This is to certify that Gerard Sidney & Jane A Jts/ -Built Garage Builders, Co.  
has permission to Construct a 960 sq ft Garage with 2nd Floor Area  
AT 14 Brabrook Rd 091 R001001

## City of Portland, Maine - Building or Use Permit Application

Proposed Project Description: Construct a 960 sq ft Garage with 2nd Floor Storage Area <i>my</i>	<table border="1" style="width: 100%; border-collapse: collapse;"> <tr> <td style="width: 50%;"> <b>FIRE DEPT:</b>  <input type="checkbox"/> Approved  <input type="checkbox"/> Denied  <i>N/A</i>                  Signature:             </td> <td style="width: 50%;"> <b>INSPECTION:</b>                  Use Group: <i>U</i> Type: <i>SB</i>  <i>BOCA 99</i>                  Signature: <i>[Signature]</i> </td> </tr> </table>	<b>FIRE DEPT:</b> <input type="checkbox"/> Approved <input type="checkbox"/> Denied <i>N/A</i> Signature:	<b>INSPECTION:</b> Use Group: <i>U</i> Type: <i>SB</i> <i>BOCA 99</i> Signature: <i>[Signature]</i>
<b>FIRE DEPT:</b> <input type="checkbox"/> Approved <input type="checkbox"/> Denied <i>N/A</i> Signature:	<b>INSPECTION:</b> Use Group: <i>U</i> Type: <i>SB</i> <i>BOCA 99</i> Signature: <i>[Signature]</i>		
<b>PEDESTRIAN ACTIVI

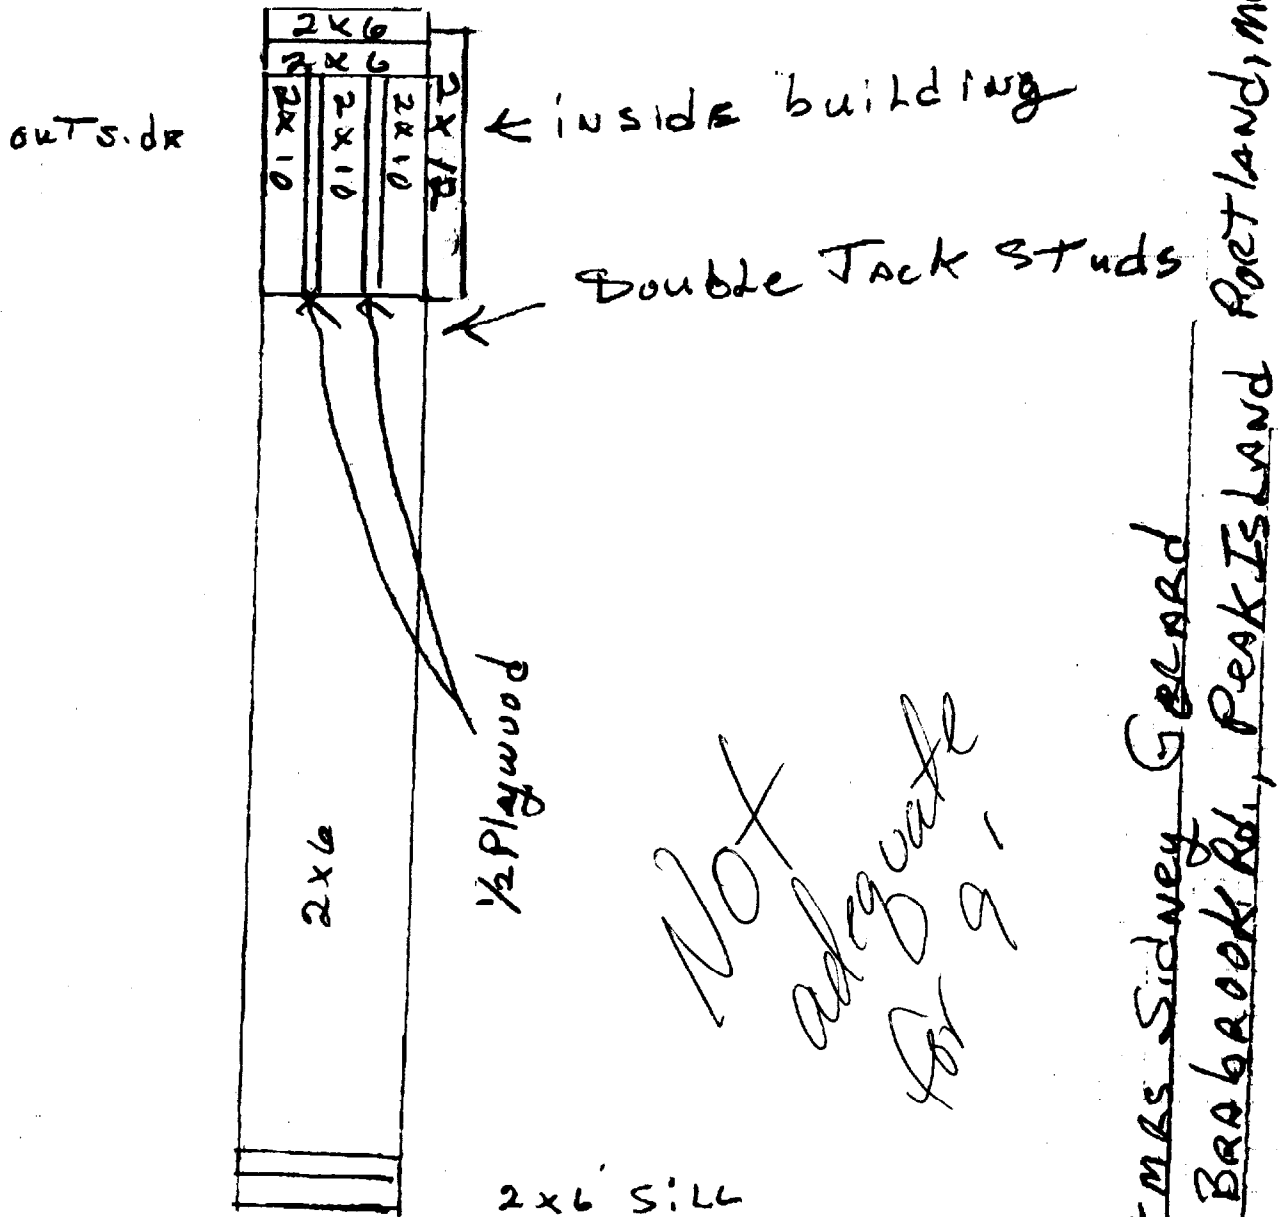
No answer or machine @ builders.

Need LVL's over 9' garage doors.  
Stairs incorrect -

4/23/03 - Went over all w/builder - only need garage door headers.

3 Garage doors 9' wide opening  
Header 10'x8" Laminated

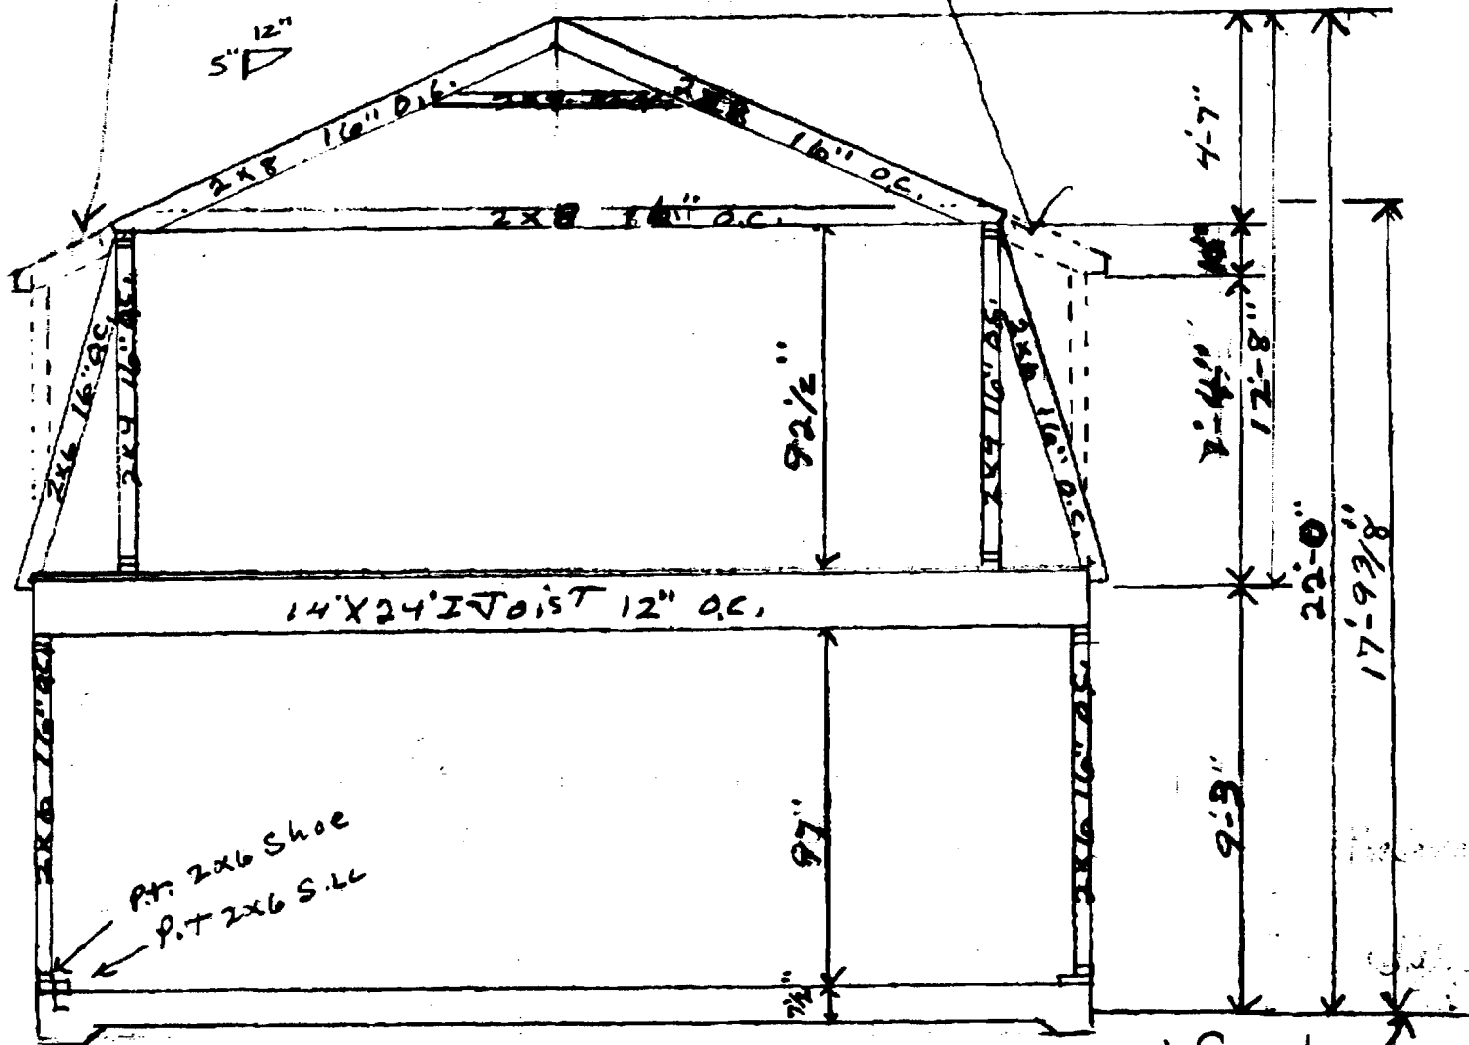
→ Shall be no ~~more~~ than 18' high

Predeveloped Grade

84' given

$$12.66 \times .67 = 8.48'$$

17.73' in height

2ND FLOOR OF  
GARAGE/  
WORKSHOP/  
STORAGE

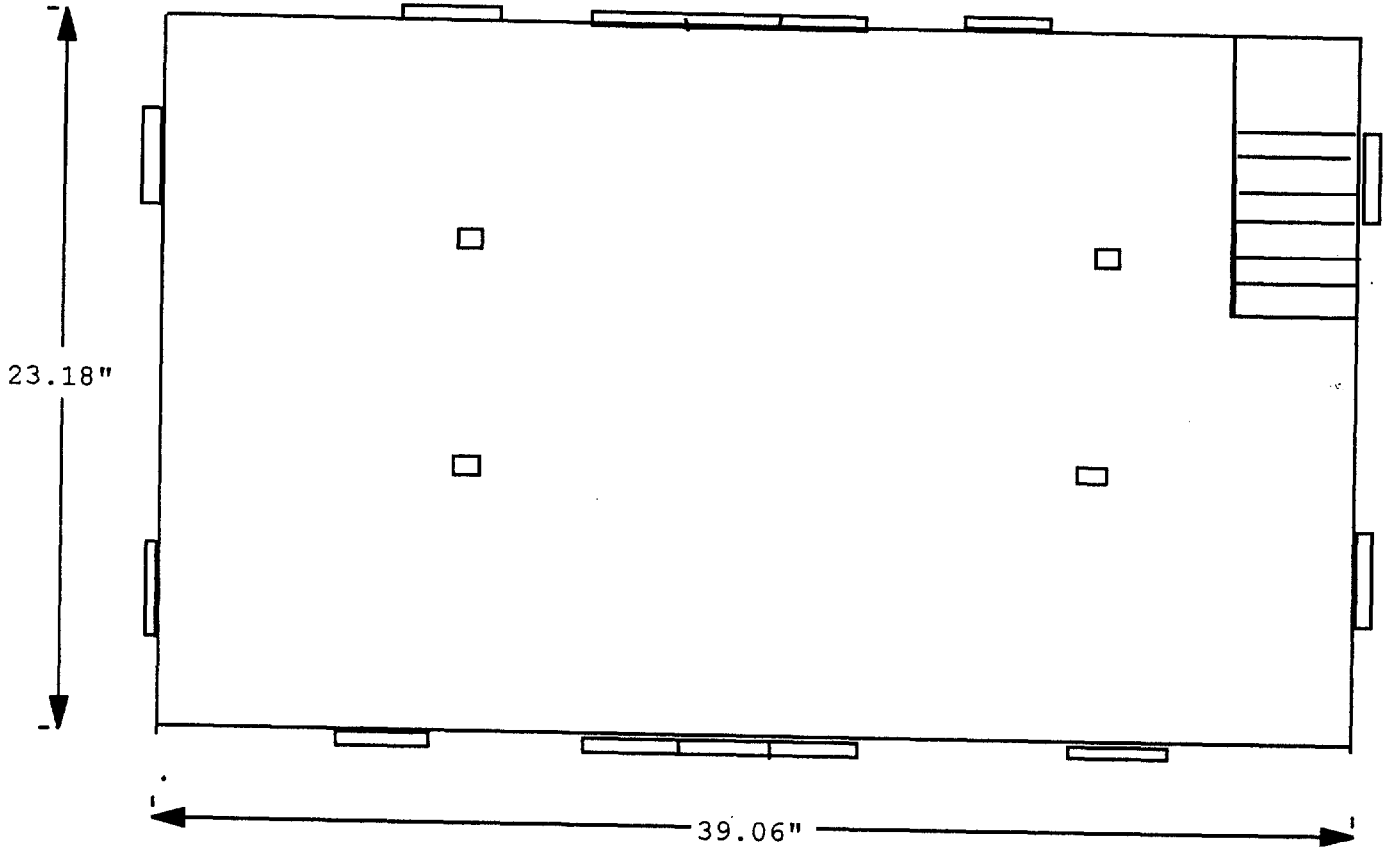
USE ?  
Cover letter status A "Storage Area"

Figure 18. FPSF Design for Unheated Space with Independent Slab and Stem Wall.

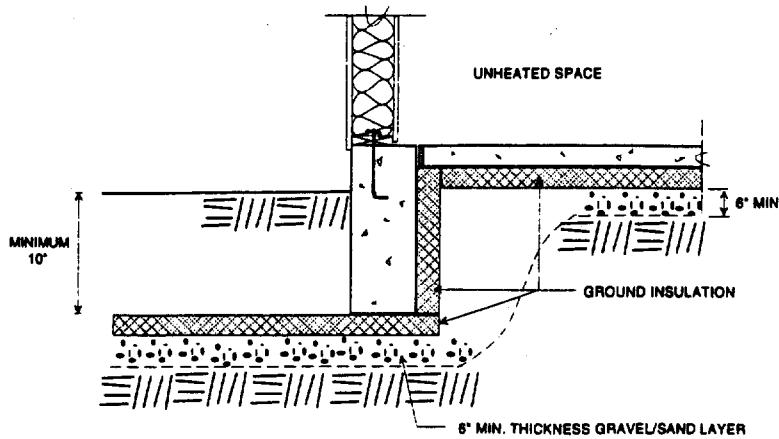
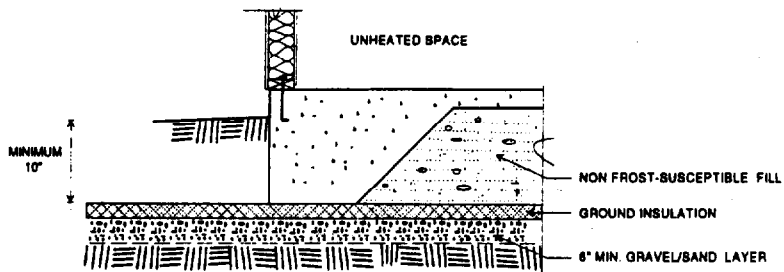
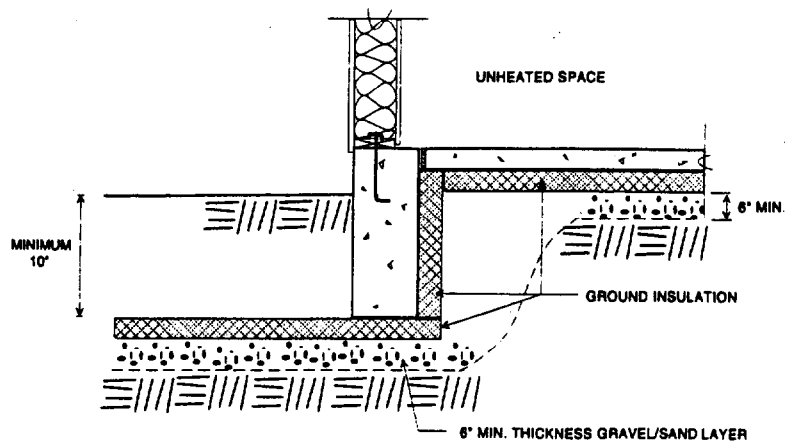
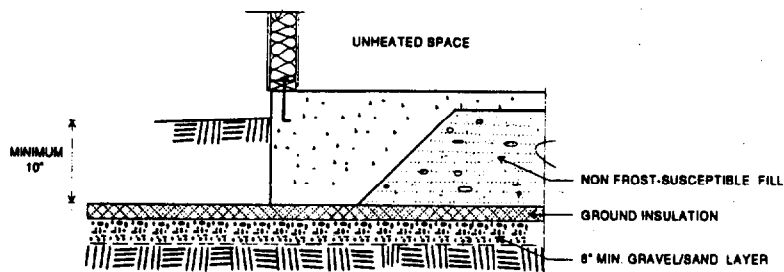
*Joe- If the garage is heated  
then it changes the requirements.*

Additional measures are required when using a FPSF on an unheated building. While a drainage layer is only recommended under wing insulation for heated buildings, a 6-inch drainage layer is always required under unheated FPSF designs. Additionally, the horizontal ground insulation extends not only as a wing beyond the perimeter of the building, but continues under the entire unheated portion of the building. This insulation layer can be installed either directly under the slab as shown in Figure 18, or entirely at one level as shown in Figure 19. In either case, the compressive load of the building on the insulation must be determined to compare to the compressive resistance of the foam (see design examples). The horizontal insulation must have a minimum of 10 inches of soil cover.

Attachment 1

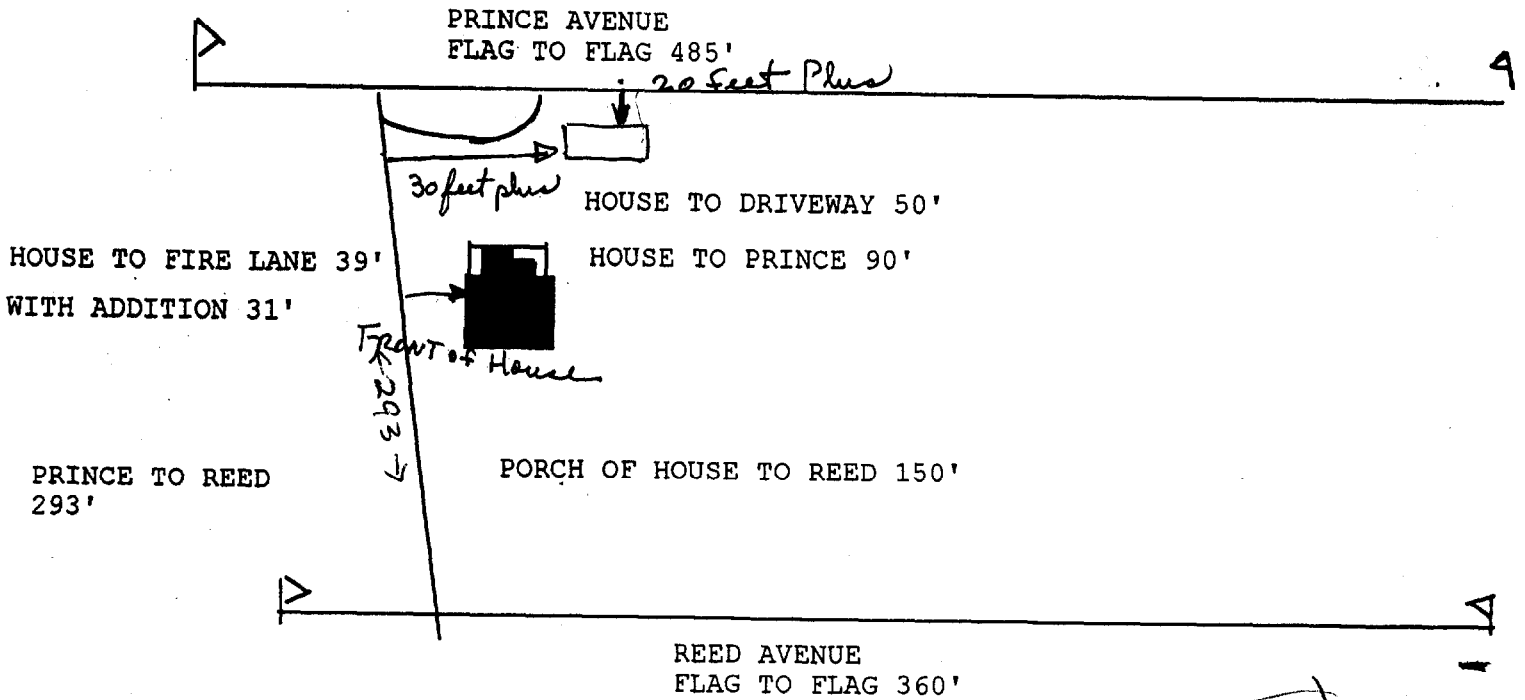
IR-1 zone

front: - 30' req - 30'+ show

rear: - 30' req - 30'+ show

side: - 20' req - 20'+ show

18' height limit to  
original grade  
predevelopment grade

See FAX dated  
3/31/03  
84' is the predevelopment  
grade level per  
owner

CEO - HAVE  
owner/contractor call when  
framed up to be sure the maximum  
height limit of 18 feet is not  
violated
